# 2023 WATER QUALITY STUDY PLAN

STEVENS CREEK HYDROELECTRIC PROJECT

FERC No. 2535

*Revision 1 August 2023*

**Figure 1.1 Example of Dissolved Oxygen<sup>1</sup> and Water Level Fluctuations<sup>2</sup> in Stevens Creek**

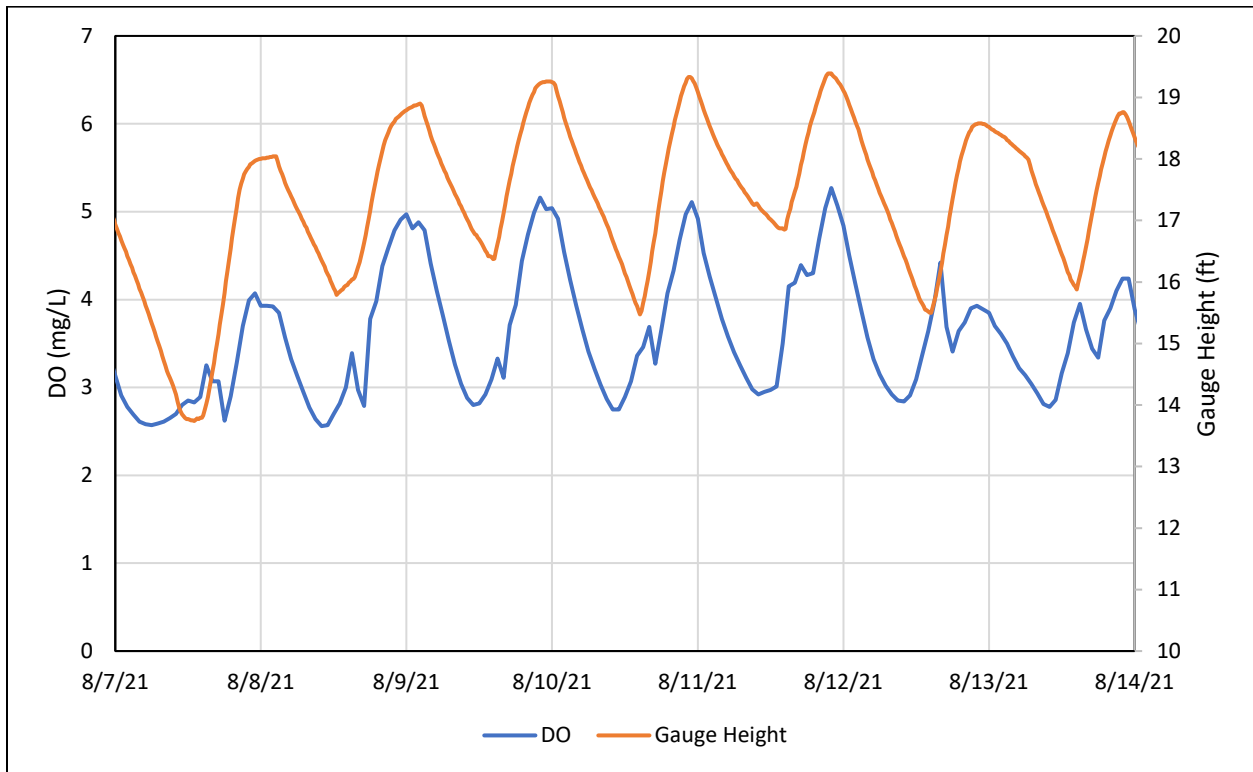
NMFS	SCWQ NMFS SC01	<p>In section 1.1, the discussion of how DO changes with temperature throughout the day is highly relevant to understanding the water quality dynamics at this project. We suggest including those analyses in revisions to the 2022 water quality report. As it stands, section 1.1 of this report is the first time these data are presented to the record.</p>	<p>The referenced discussion will be added to the 2022 water quality report as suggested.</p>

**Figure 3.1 2023 Water Quality Study Sites**

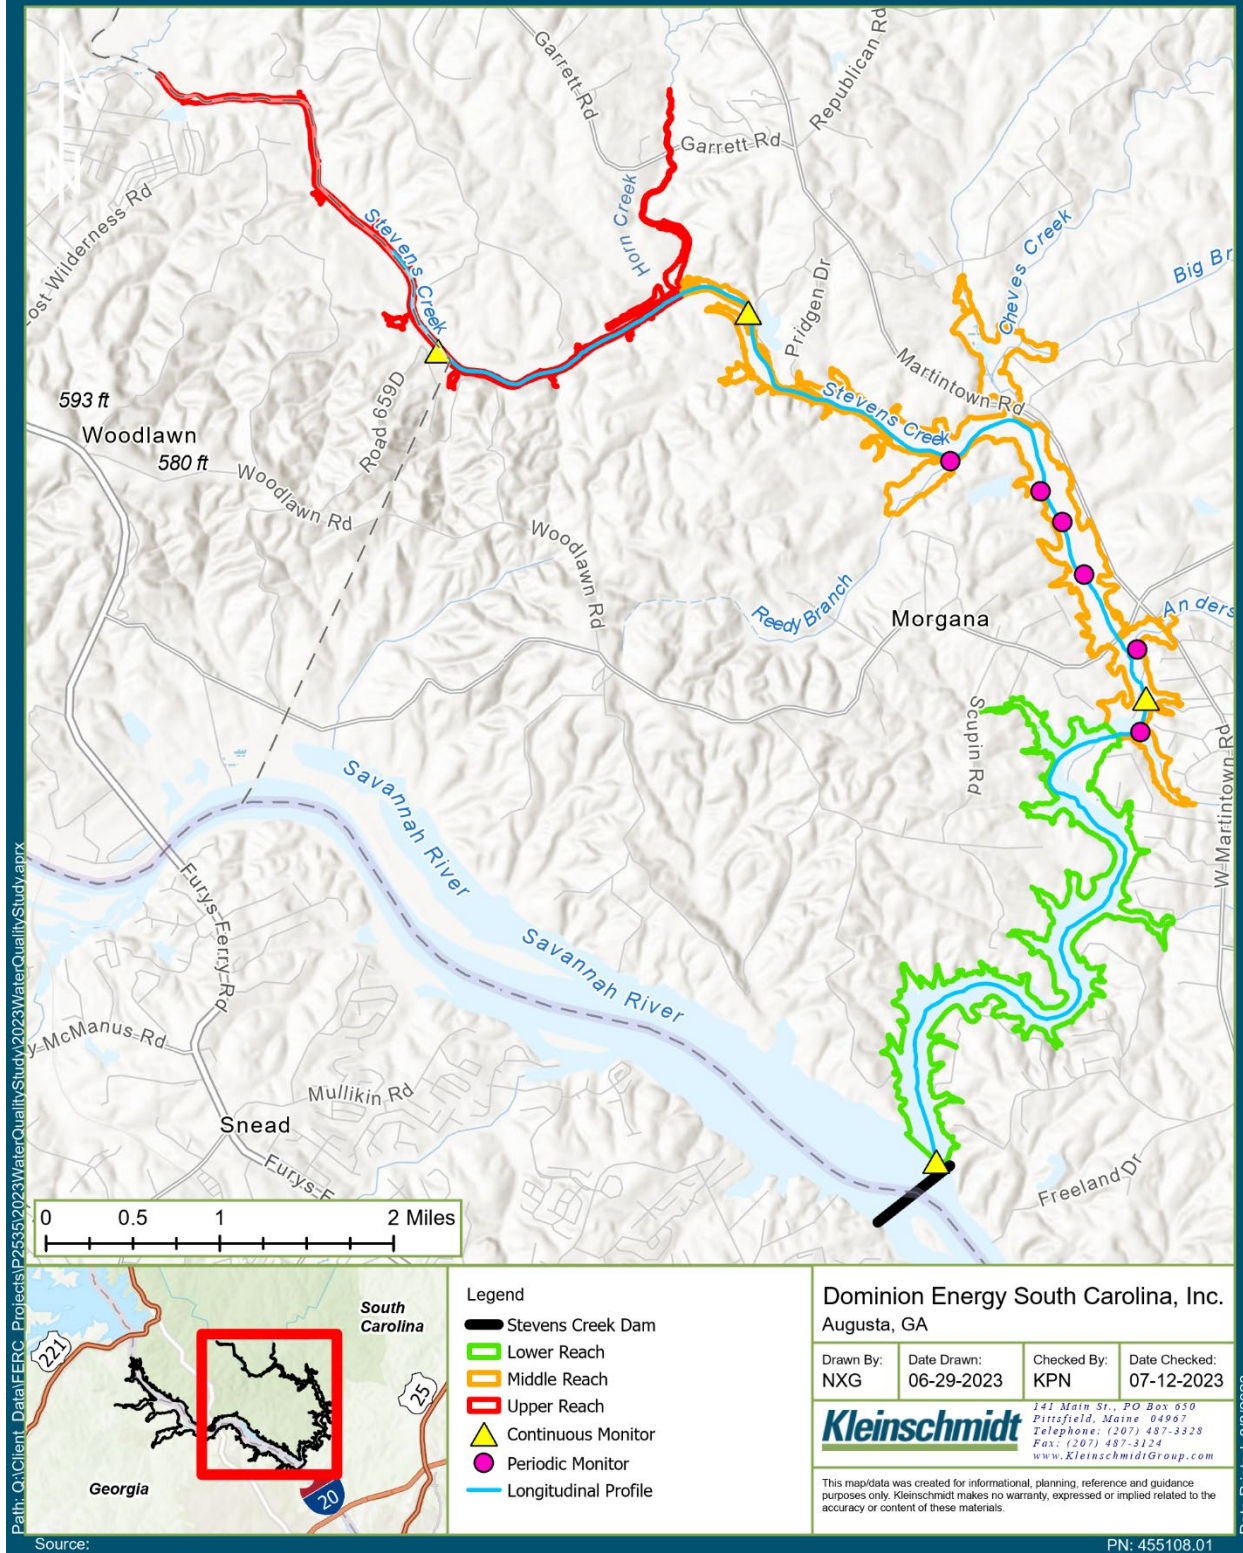
Commentor	Comment Code	Comment	Applicant Response
NMFS	SCWQ NMFS GC01	To better conceptualize the extent of hypoxic conditions in Stevens Creek, and describe the DO dynamics within the reservoir, we propose dividing the Stevens Creek branch of the reservoir into 3 reaches (Upper, Middle, and Lower), each approximately 4 river miles in length (Figure 1). The lower reach begins at the confluence with the Savannah River and extends a little over 4 miles upstream, terminating downstream of the proposed continuous monitoring site. The middle reach extends from the lower reach 4.6 river miles upstream, terminating just downstream of the confluence with Horn Creek. The middle reach would contain all of the proposed off-channel survey sites. The Upper reach extends from the middle reach another 4.16 miles, terminating at the project boundary.	The study plan has been revised to include this recommendation.

NMFS	SCWQ NMFS GC02	We recommend modifying the proposed Plan to include a continuous monitoring station at the lower bound of each reach. The two stations proposed in the Plan would serve the lower and middle reaches. An additional continuous monitoring station will need to be established in the upper reach. The agencies propose placing it just downstream of the confluence with Horn Creek. We propose deploying all three continuous monitoring stations year round, recording WQ data every hour. Those data will be used as the lowest-resolution method of tracking hypoxic conditions as they move through the system.	An additional continuous monitoring station was established directly downstream of the confluence with Horn Creek as recommended. All three continuous monitors will be deployed from May 1 through October 31, 2023. Vast water quality data has been collected within the Project boundary, including in Stevens Creek. The objective of this study was to determine the extent and duration of low dissolved oxygen levels within Stevens Creek, which data indicate occurs between May and October. Dominion feels that existing data is adequate to characterize water quality during shoulder seasons and additional data collection outside of the proposed time frame is unnecessary for the purposes of understanding potential project effects to water quality.

Commentor	Comment Code	Comment	Applicant Response
NMFS	SCWQ NMFS SM01	For continuous monitoring a) Establish an additional continuous monitoring station just below the confluence of Stevens Creek and Horn Creek. b) Deploy continuous monitoring stations year-round.	A continuous monitor was established just below the confluence of Stevens Creek and Horn Creek as recommended. The monitors will be deployed from May 1 through October 31, 2023. The objective of the study was to determine the extent and duration of low dissolved oxygen levels within Stevens Creek, which data indicate occurs between May and October. Dominion feels that existing data is adequate to characterize water quality during shoulder seasons and additional data collection outside of the proposed time frame is unnecessary for the purposes of understanding potential project effects to water quality.
NMFS	SCWQ NMFS SM02	For Longitudinal Surveys Each survey should consist of an up- and downstream tow, beginning at the confluence of Stevens Creek and the Savannah River and sampling the entire 12.77 river miles of Stevens Creek within the project boundary (or vice versa). b) Conduct one survey each month from May through November, and conduct an additional two surveys between December and April for a total of 9.	The longitudinal surveys will be conducted at least monthly from May through October and cover from the mouth of Stevens Creek to approximately 10 river miles upstream, which is the furthest the motorboat can travel. Longitudinal surveys are not planned to occur between November and April as the objective of the study was to determine the extent and duration of low dissolved oxygen levels within Stevens Creek, which data indicate occurs between May and October. Dominion feels that existing data is adequate to characterize water quality during shoulder seasons and additional data collection outside of the proposed time frame is unnecessary for the purposes of understanding potential project effects to water quality.
